# Temperature sensors on APAs

IFIC-Valencia

# Introduction

# Problem 2: cable tie/clamp not present

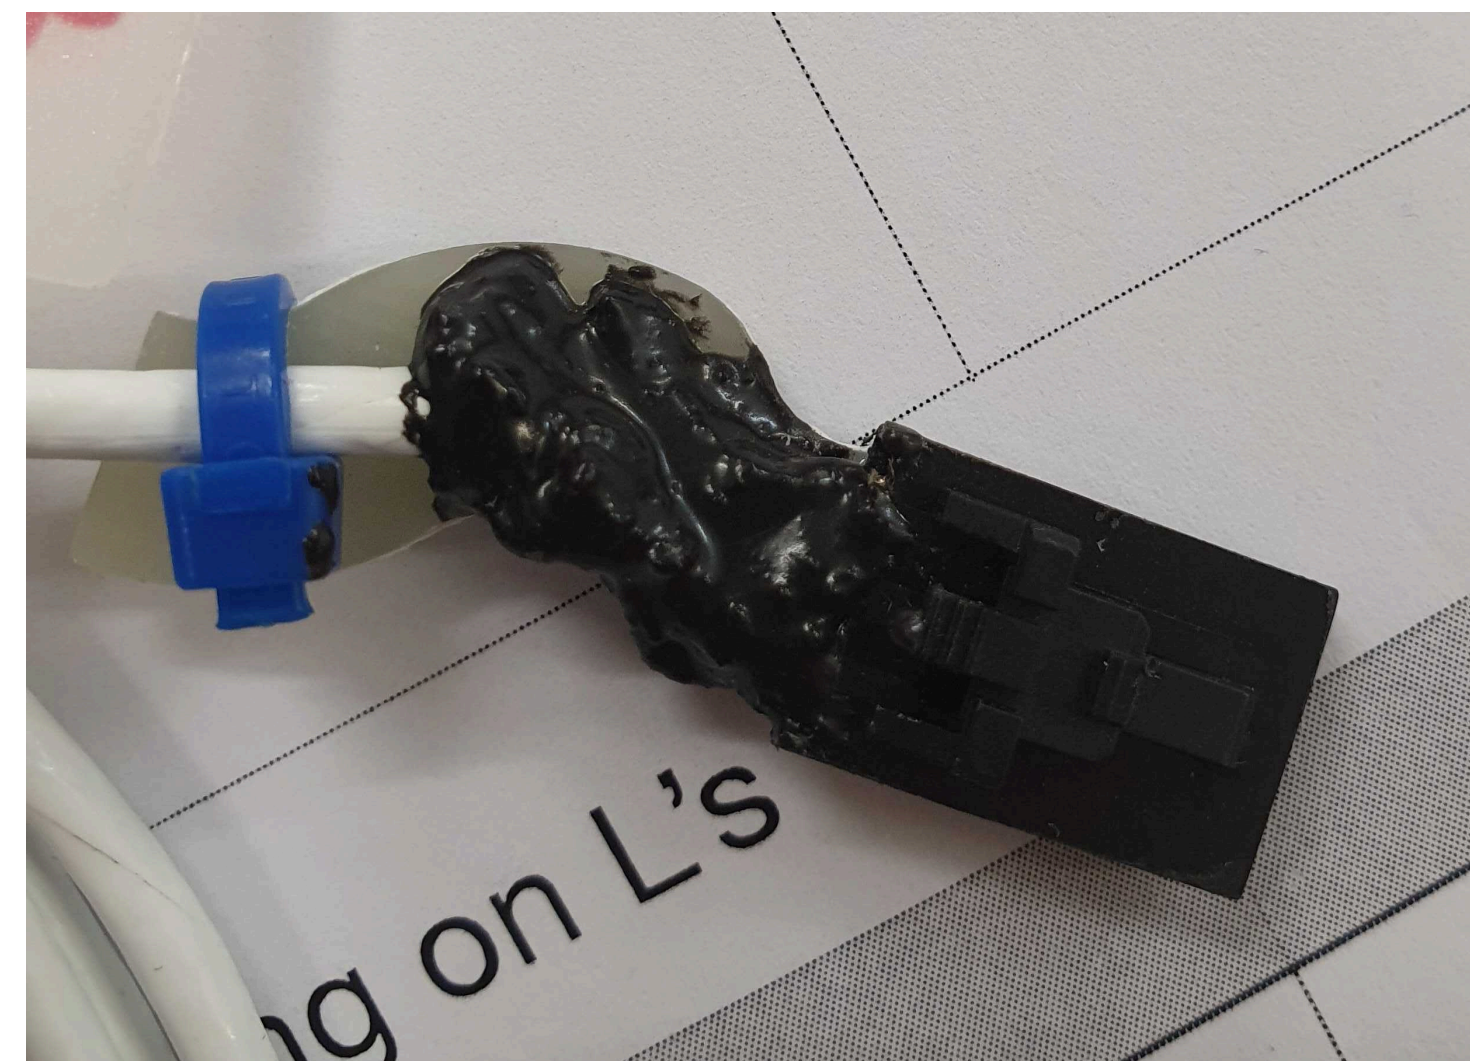
- After APA 13 we decided to remove the cable tie/clamp in order to simplify the manufacturing process
- However we have noticed that the assembly is more robust with it
- In consequence, these elements will be restored

# Problem 3.a: Epoxy quality

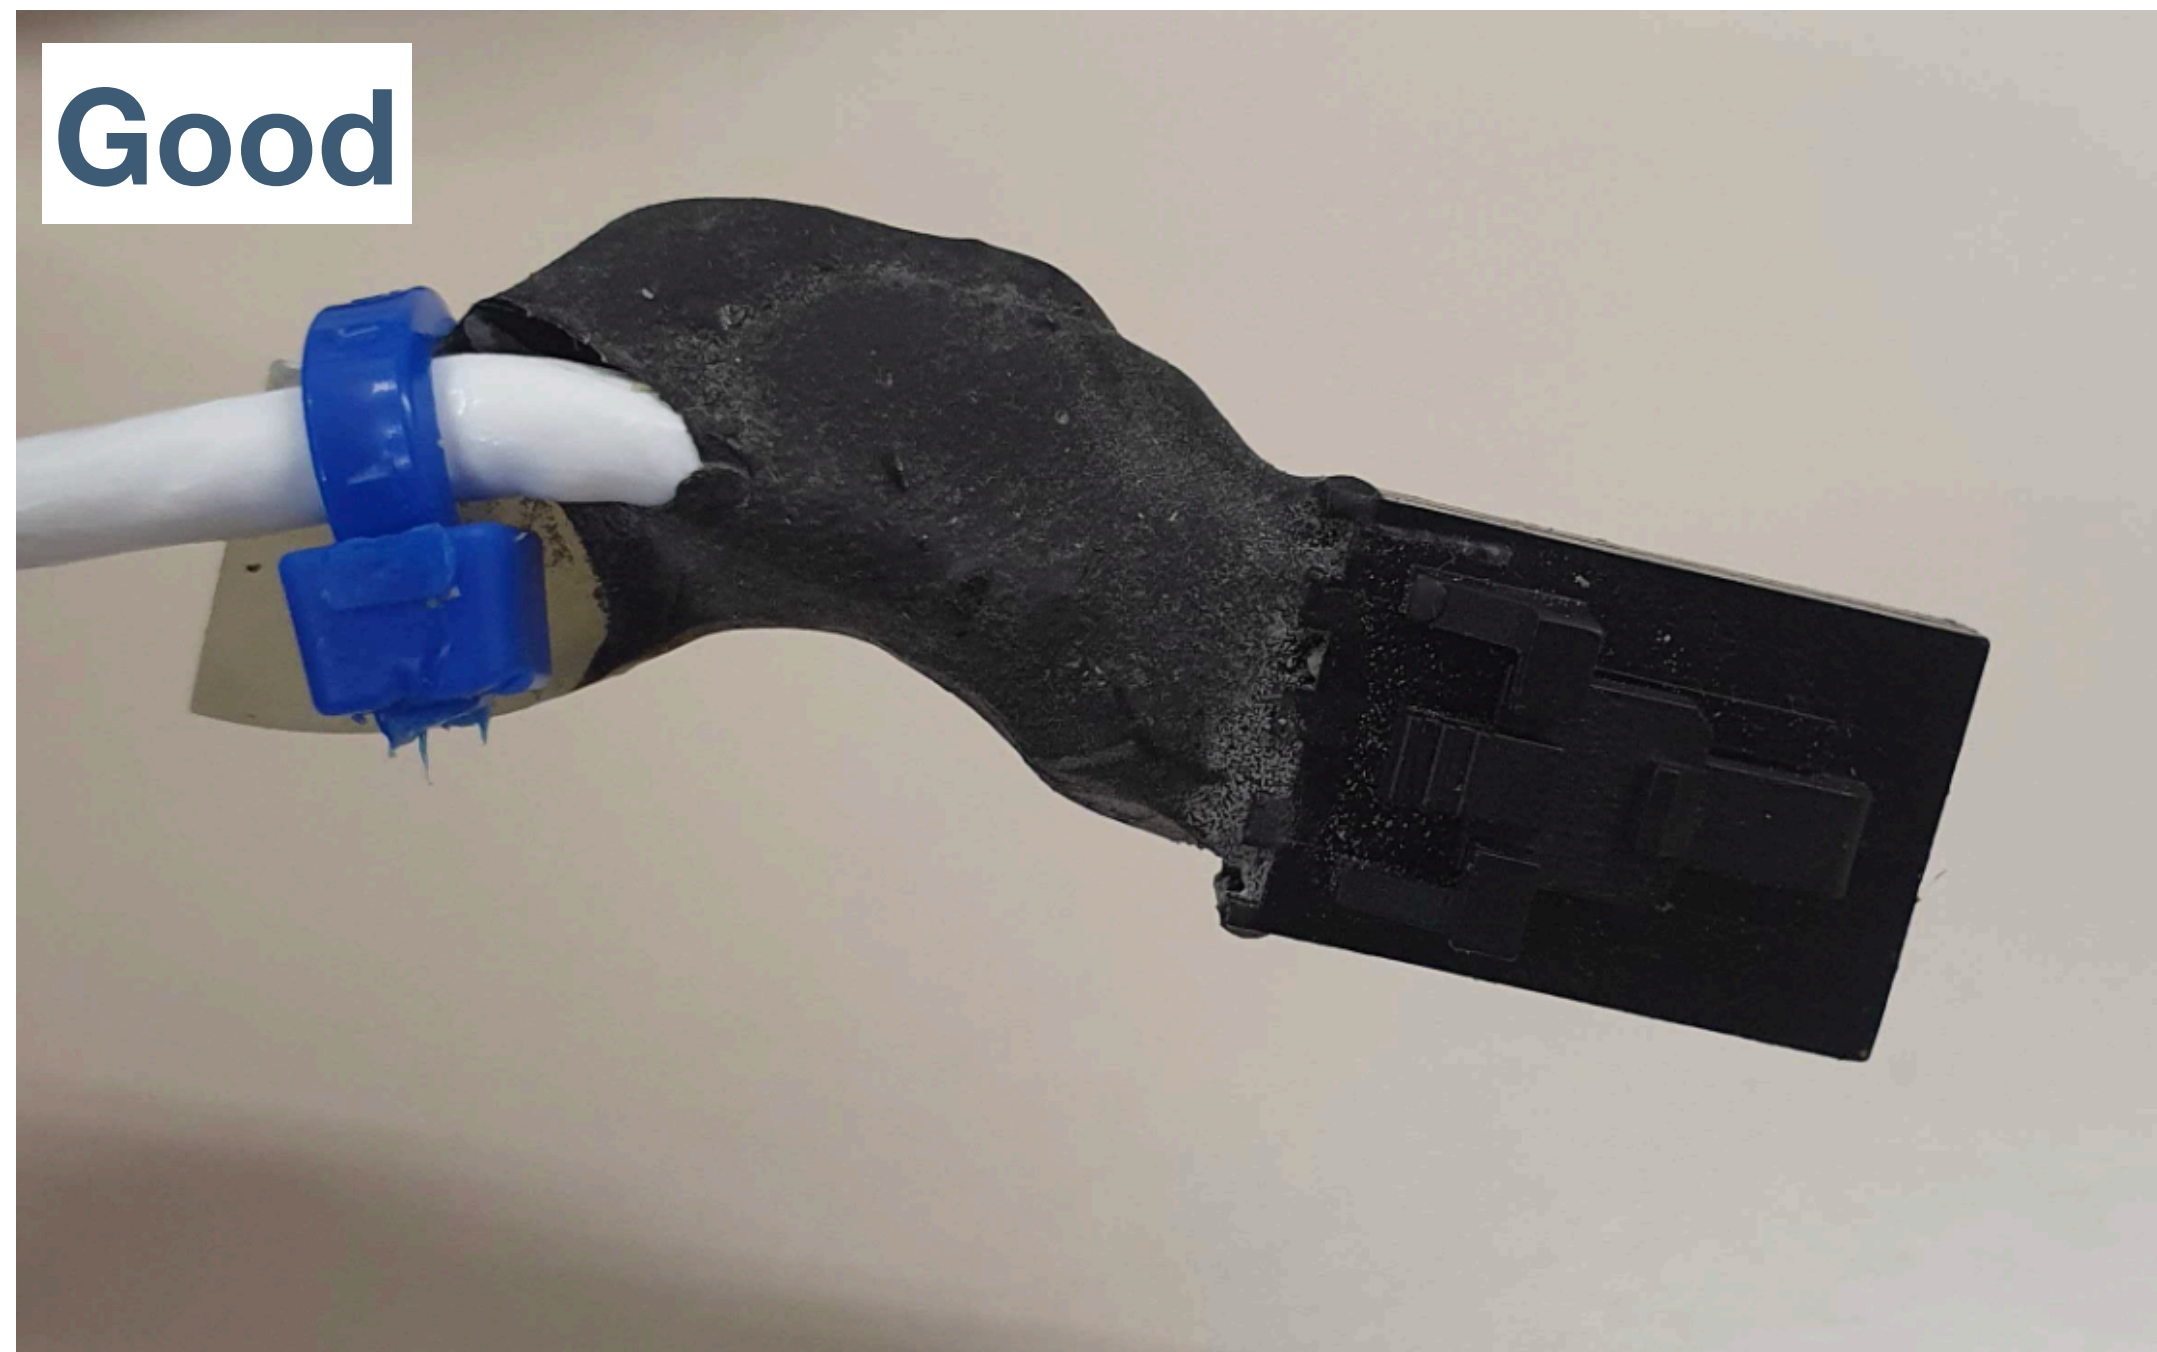
- Sometime it is only aesthetics
- **Repair:** add more epoxy with proper distribution
- **Changes in production:** remove bubbles before applying epoxy
- **Changes in QA/QC:** look at aesthetics

# Problem 3.c: Epoxy quality

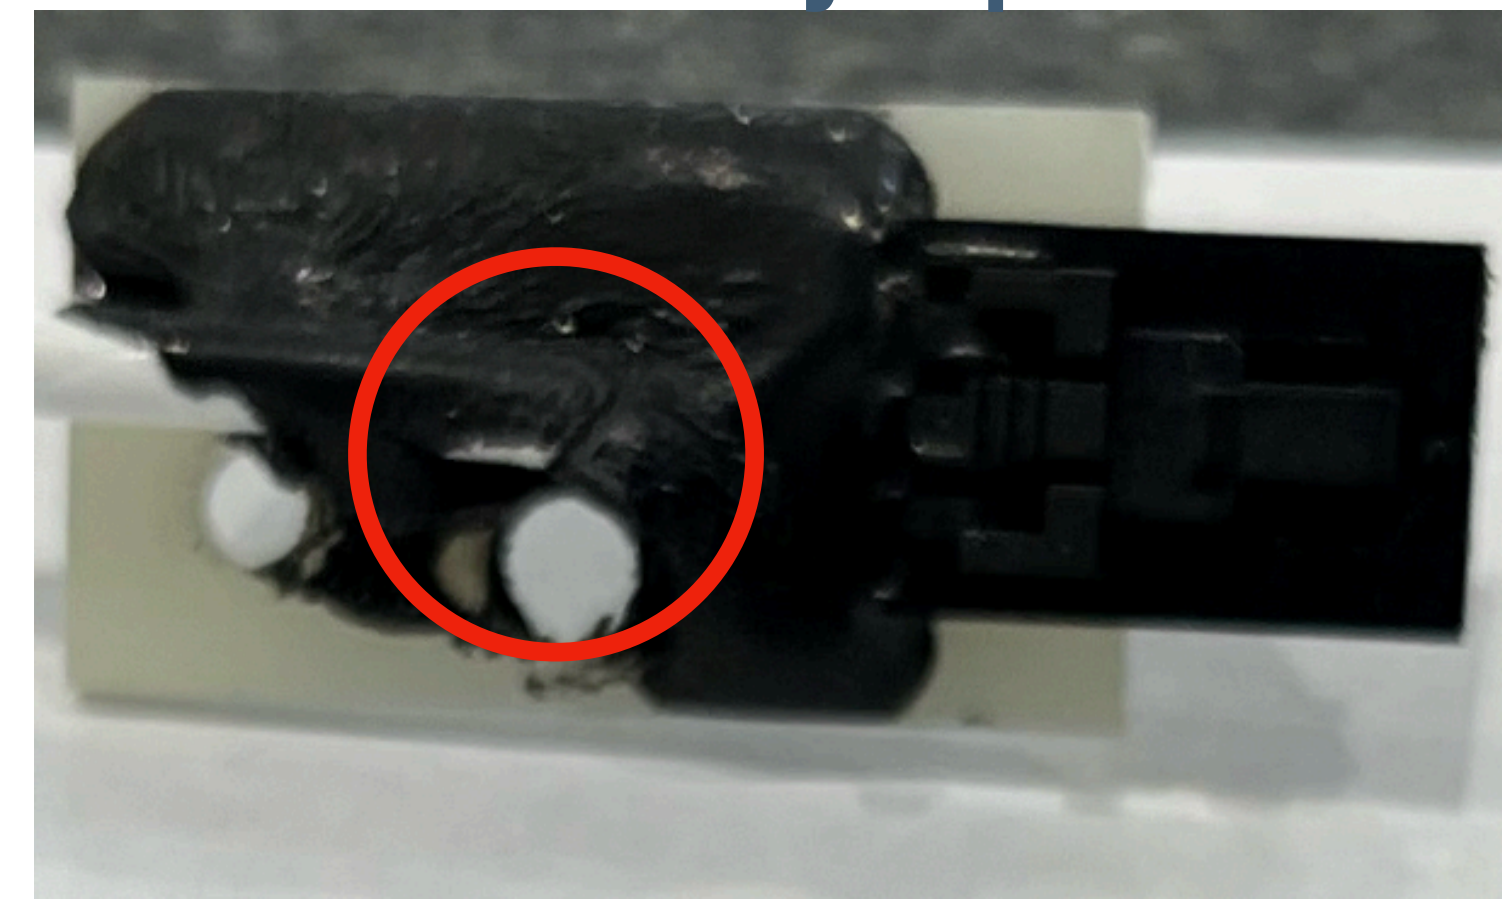
- Epoxy prevents housing the M4 screw head
- **Repair:** remove extra epoxy with a drilling machine
- **Changes in production:** none, a temporary bolt is used when adding epoxy
- **Changes in QA/QC:** mount entire kit

Cable is too close, cannot be easily repaired

# Problem 3.d: Epoxy quality

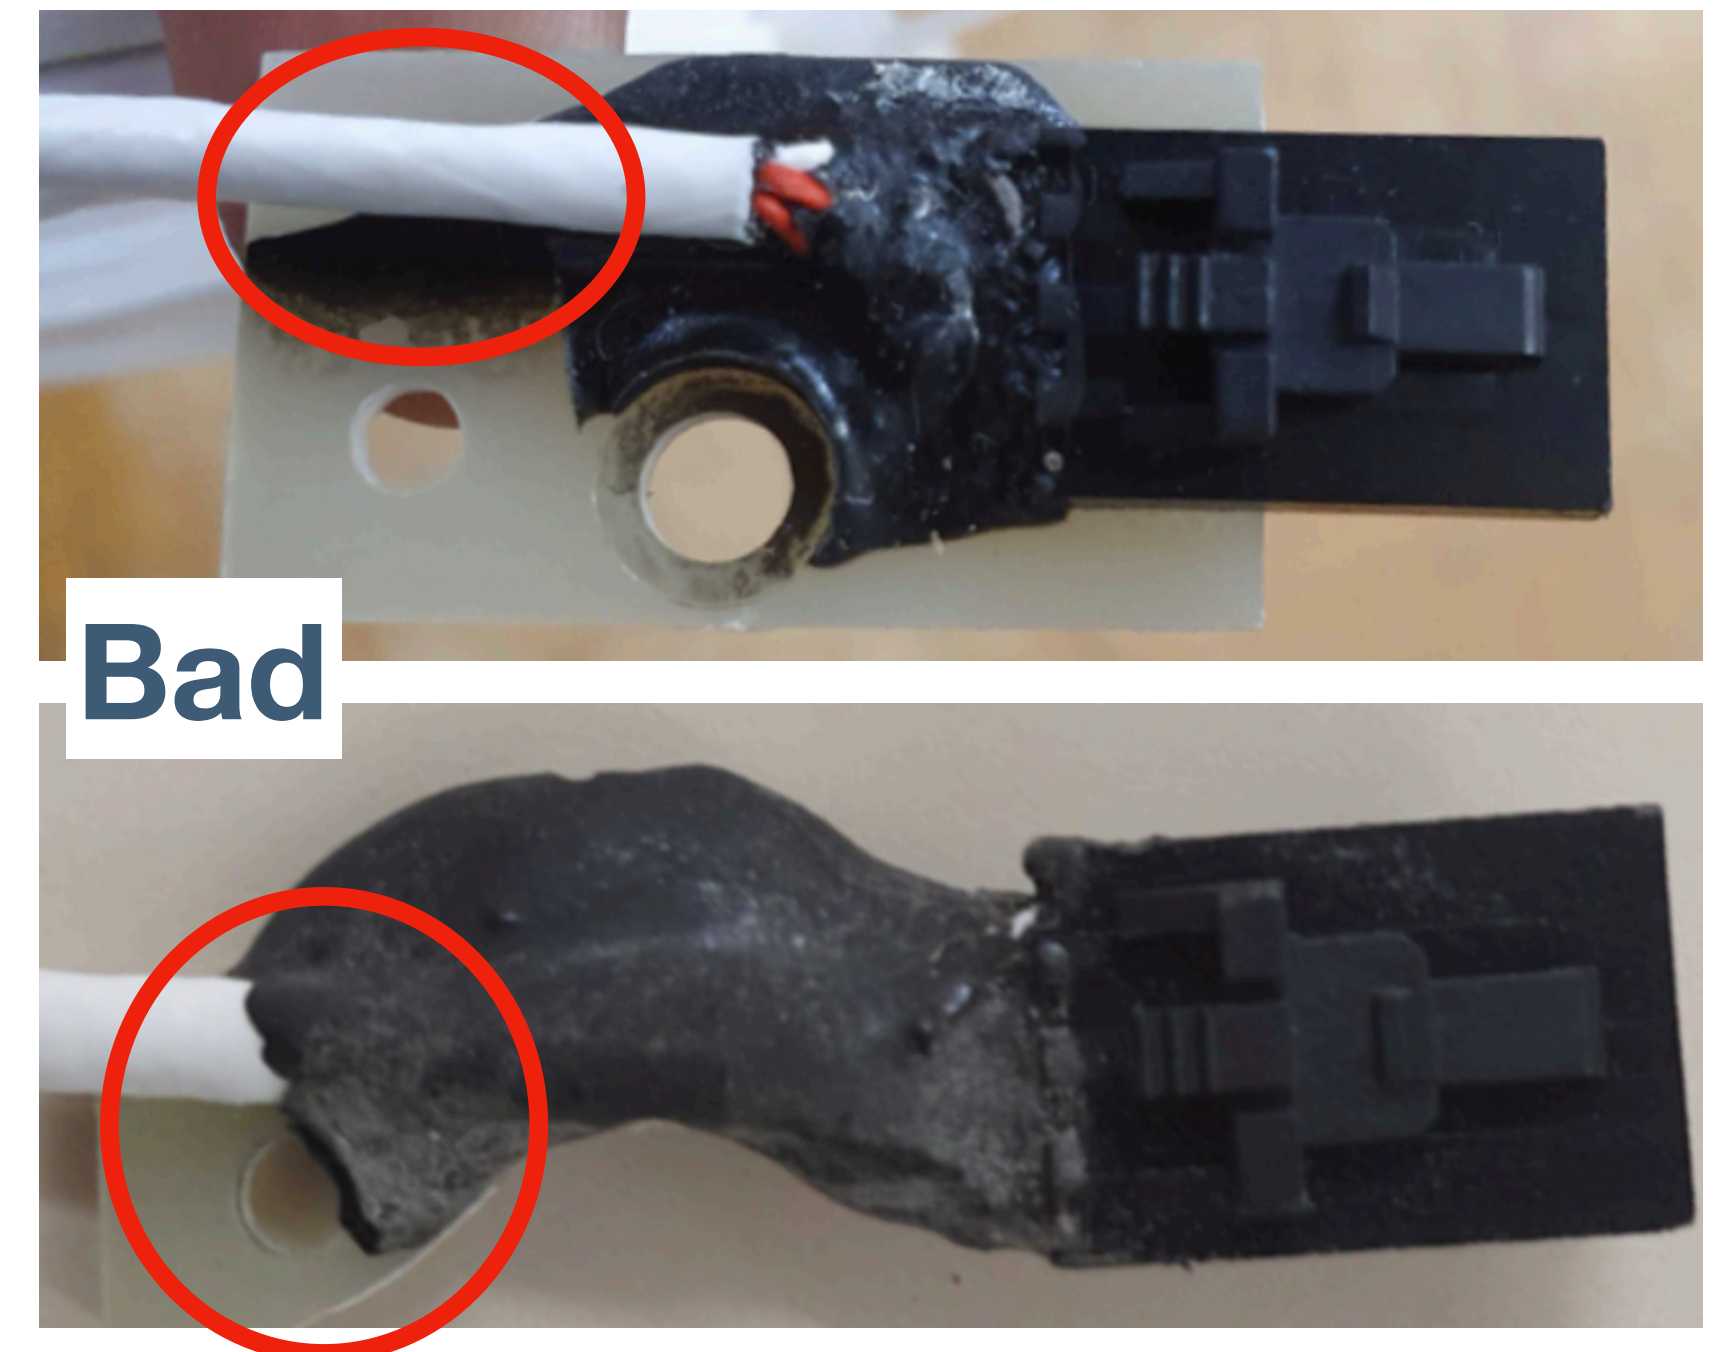
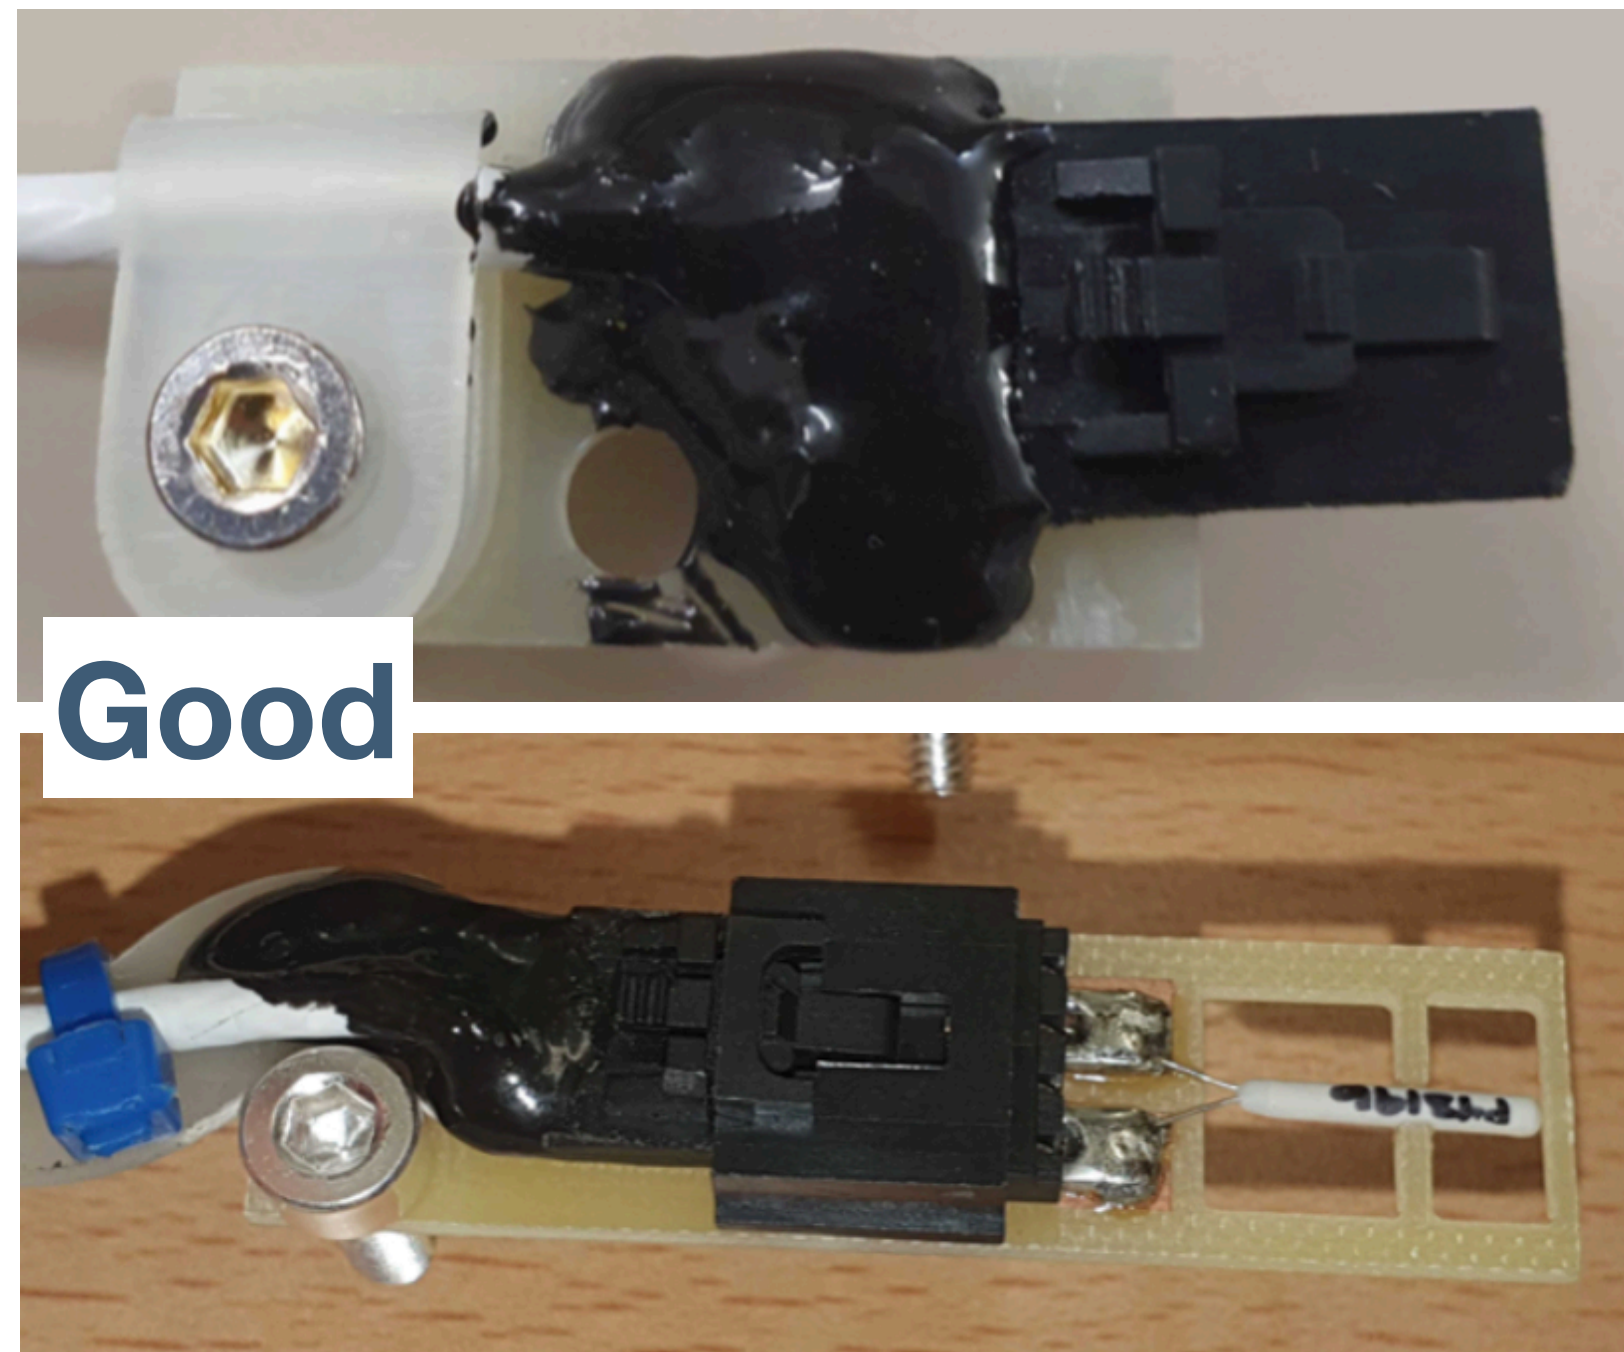
- Epoxy prevents adding the cable clamp/tie
- **Repair:** remove extra epoxy when possible
- **Changes in production:** add cable tie/clamp before epoxying
- **Changes in QA/QC:** make sure cable tie/clamp is present before
